RII - AED PROCESSOR CARD_MPC8358 DDR MEMORY

ATS-AED-PROC SCH-001

AutoTEC
R11 - AED PROCESSOR CARD_SDRAM INTERFACE
 Size A3 Document Number **ATS-AED-PROC SCH-001** Rev 4.0
 Date: Wednesday, June 17, 2020 Sheet 14 of 44

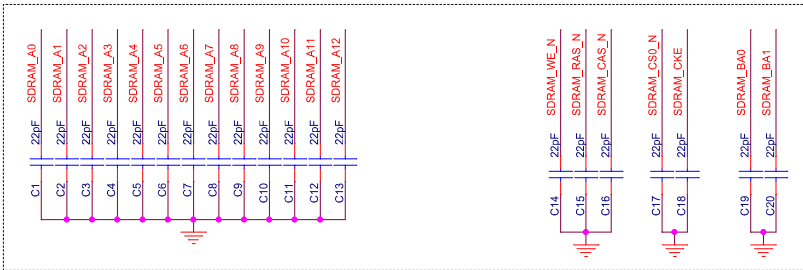
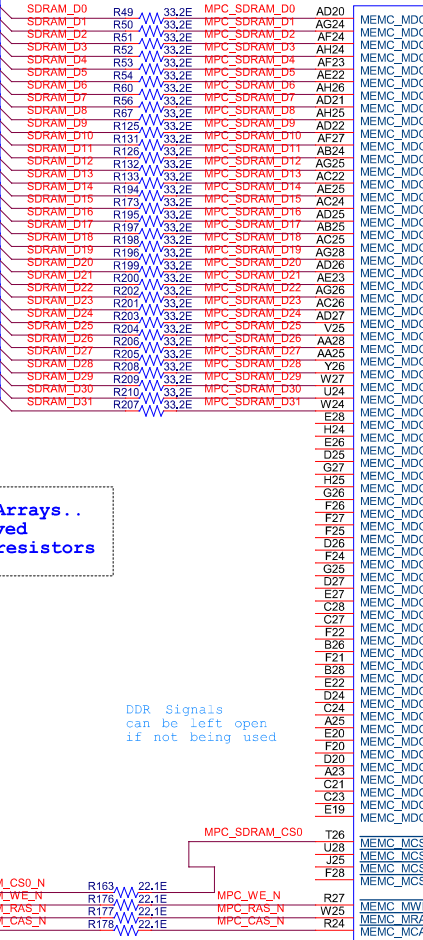
Changed in Rev 4.0

Series termination provided through Resistor Arrays.. namely...RN17 to RN25, RN28 to RN30 are removed & termination is provided through individual resistors

22.1E series termination added to the CLK_P & CLK_N outputs from the Processor

Changed in Rev 4.0

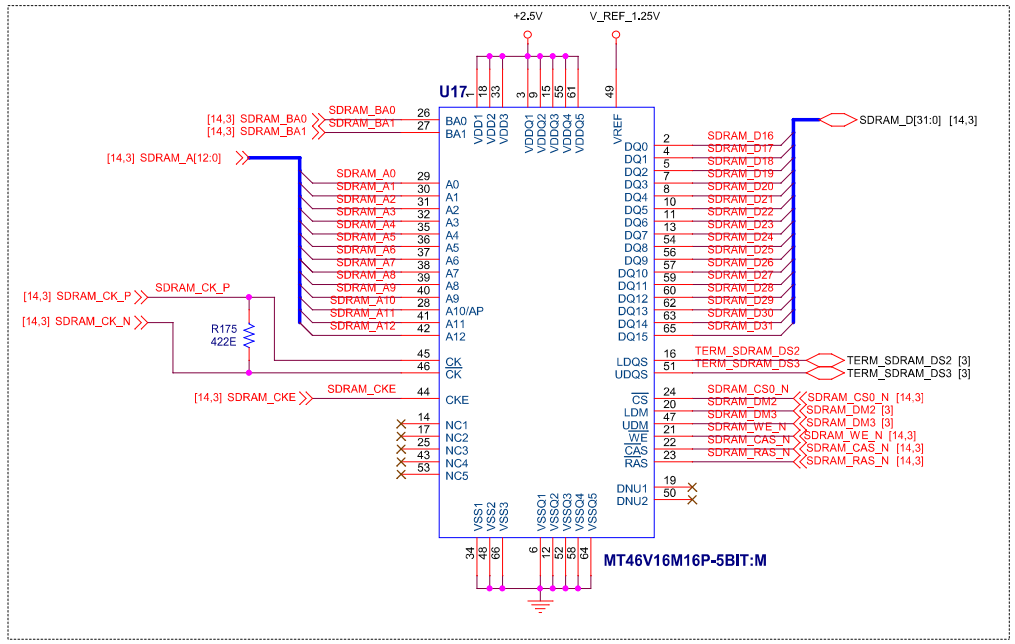
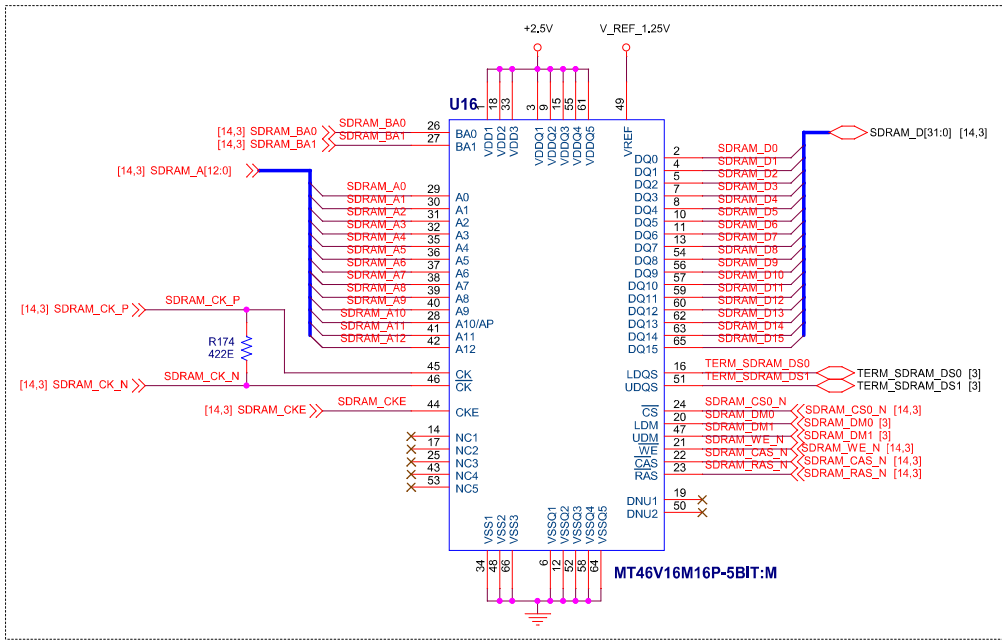
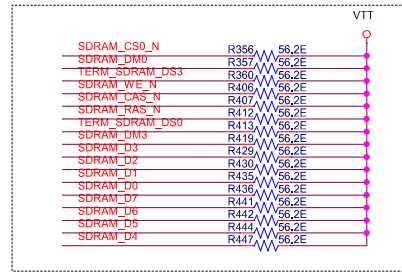
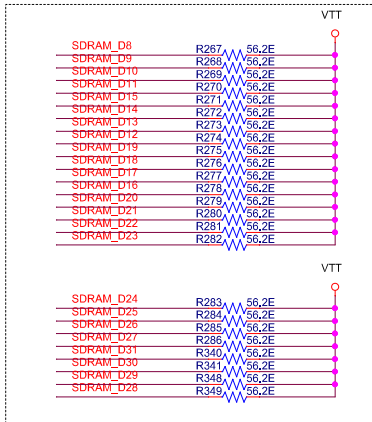
Changed in Rev 4.0

Series termination provided through Resistor Arrays.. namely.. RN31 to RN44 are removed & termination is provided through individual resistors
